TECHNICAL BULLETIN

[Issue No.] No. HIME-T-P-0145A

[Title] GT2103 boot display improvement

[Relevant Models] GT2103-PMBD, GT2103-PMBDS, GT2103-PMBDS2, GT2103-PMBLS

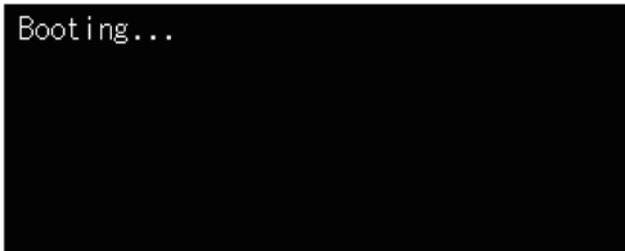
GOT2000 series (GT2103) has been improved to display “Booting...” upon power-up in BootOS versions 01.08.000.-F and later.

Improvement was made such that “Booting...” will be displayed 1 second after power-up to clearly indicate that the GOT is booting.

4.1 Checking by nameplate

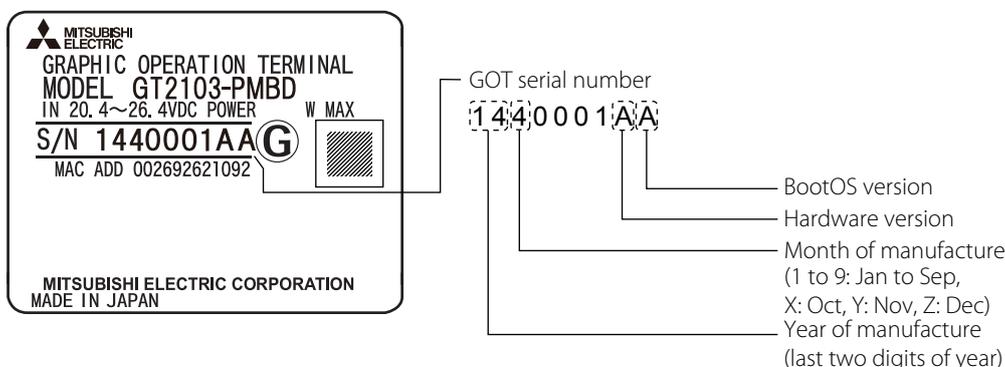
To check whether improvement is applied by checking the nameplate, refer to 4.1 Checking by nameplate.

Check the nameplate on the back of the GOT, and check the BootOS version.

If BootOS version is 'F' or later, the improvement is applied.

If BootOS version is less than 'F' ('A' to 'E'), the improvement can be applied by performing 5. Method to update BootOS.
